DATE	TOPIC
1/29/2025	Updated the flow chart for clarity, added additional detail on how to handle oversized/undersized batteries and added the disclosure form to the end of the document.
1/23/2025	Updated the initial battery inspection
1/14/2025	Updated the Flow Chart
1/8/2025	Updated the Positive cable routing

## **SAFETY RECALL 23TA13**

**Potential Vehicle Fire related to 12-volt battery**

### **CERTAIN 2013 - 2018 RAV4 VEHICLES**

**5. INSTALL HEAD OF POSITIVE (+) TERMINAL AND *NEW* CONNECTOR COVER.**

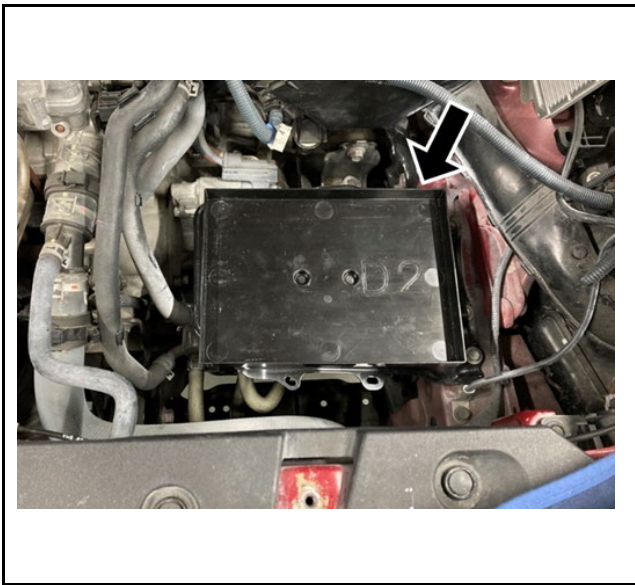
Route the positive battery cable on the bracket between the j-hook and air cleaner

**6. INSTALL *NEW* BATTERY TRAY.**

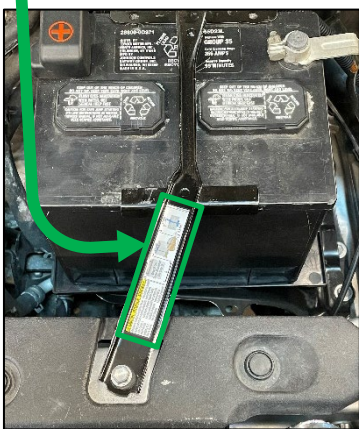
**NOTICE:** If the correct group 35 battery is not installed, ensure the battery tray fits properly. Properly fitted means the battery can sit within the tray and does not rest on the raised edges. If the battery does sit on the raised edges, the battery hold down cannot be properly torqued. In this case, use the original tray in the vehicle and provide the tray from the recall repair kit to the customer. Document any discrepancies on the Disclosure form if applicable.
